## ● **50-140, 50-142 GEARBOX ASSEMBLY**

**MODELS:** • PFM 9.2  
• PFM 9.0  
• PFM900  
• VBG620**50-140, 50-142 GEARBOX ASSEMBLY**

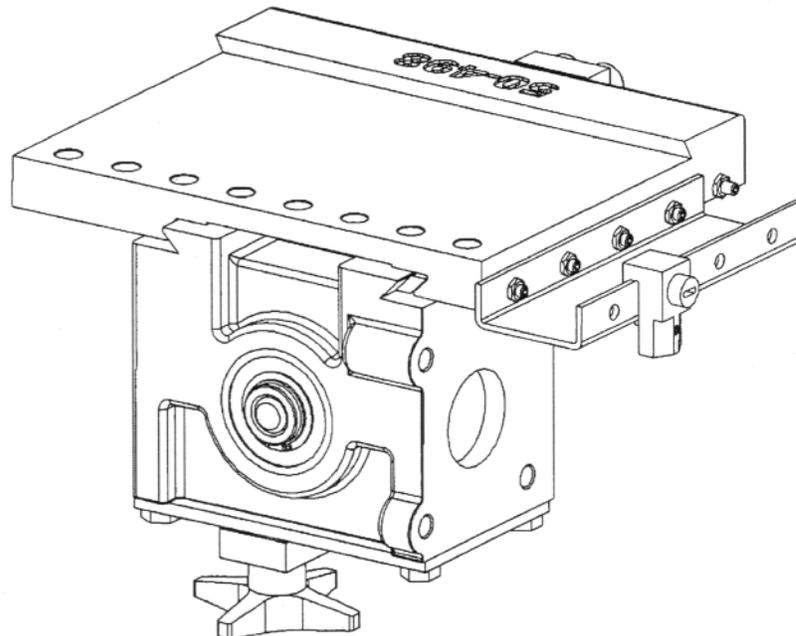
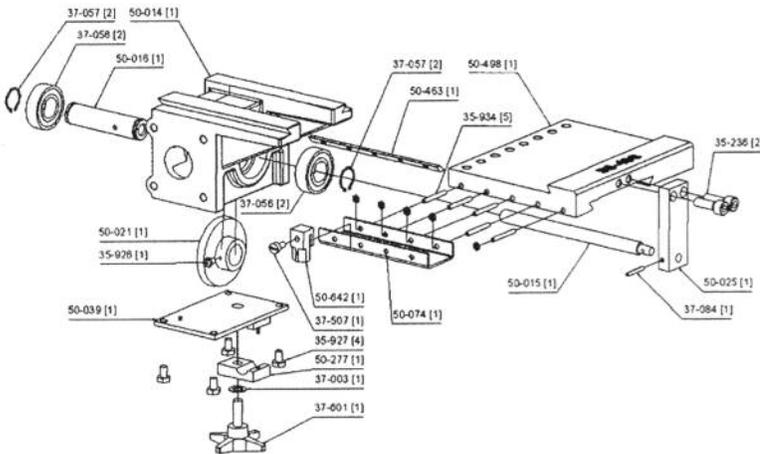
The **50-140** Gearbox Assembly varies from the **50-142** Gearbox only in the width of the shutoff cam rail. The narrower version (50-073) on the 50-140 assembly allows the 50-140 Gearbox to function on the PFM 9.2 Series and VBG 610/620 Series.

The new 50-140 and 50-142 gearbox assemblies offer the following improvements:

- Greater inboard reach—21mm/0.84" more
- Increase in disc diameter capacity—an increase of 19mm/0.75" to 350mm 13.75" [355mm/14" absolute maximum at zero clearance] on 9.0/900 & 610/620 series lathes.
- Substantially wider slides (28.5mm/1.12")—increased stability and damping, smoother travel
- Improved gib design—better contact area—less frequent gib adjustment required.

To achieve the increase in rotor diameter, the plastic gear's position was reversed, moving it away from the rotor. By changing to a left-hand thread for the feed screw and nut, the feed direction was maintained without the need for any other modifications. Feed rate is unchanged.

The gib screws have different style tips than those in the old **50-640** assembly and the gib has redesigned tip screw pockets, resulting in greater area in contact between the gib and the gearbox slides. This increases the service interval as the wear rate is lower. Neither the shutoff cam rail, gib, nor

gib screws from the old assembly are compatible with the new design (although the thread size on the gib screws is unchanged: M4).

Parts compatible with the older **50-640** assemblies include the bearings, gear, snap rings, and feed block (**50-025**). The slide plates (**50-499** from the older design and **50-498** from the new design) are not interchangeable, nor are the gib and gib screws.

This assembly cannot be retrofit to an existing lathe body without also replacing the feed shaft assembly with a new feedshaft (**50-661** or **50-668**—explanation follows below) due to the greater space between the mounting surface and the white plastic gear. Feed shaft replacement is not recommended for end users as the alignment process of the two white plastic gears is critical. If performed, it should be done by properly trained Pro-Cut representatives. Concentric rings in the rotor may result if gears are not properly aligned.
